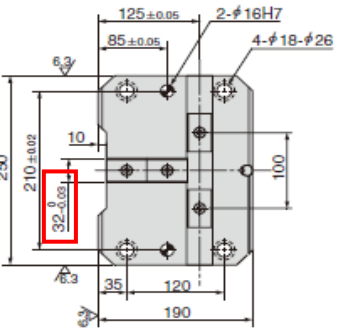
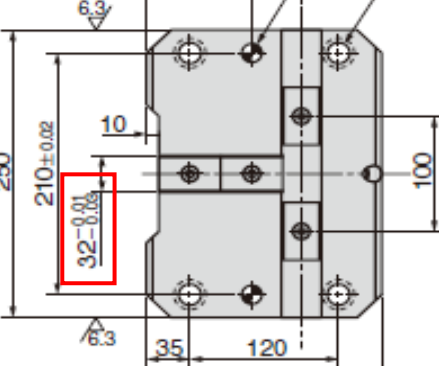
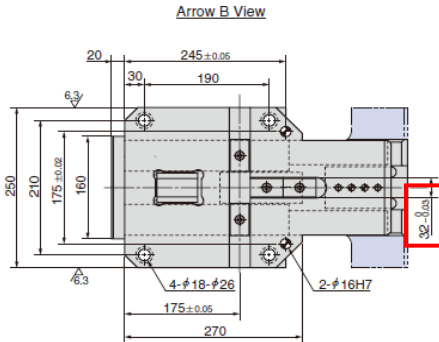
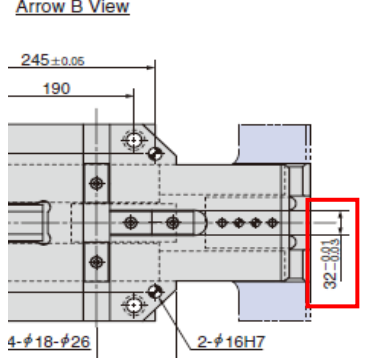
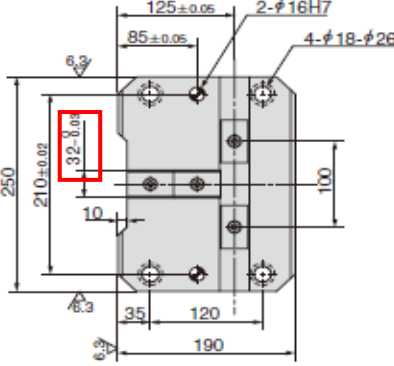
ページ	品名	誤		正
737	WCMSH	<p>キー交差 0 -0.03</p> 	<p>-0.01 -0.03</p>	
738	WCMSH	<p>キー交差 0 -0.03</p> 	<p>-0.01 -0.03</p>	<p>Arrow B View</p> 
741	WCMS	<p>キー交差 0 -0.03</p> 	<p>-0.01 -0.03</p>
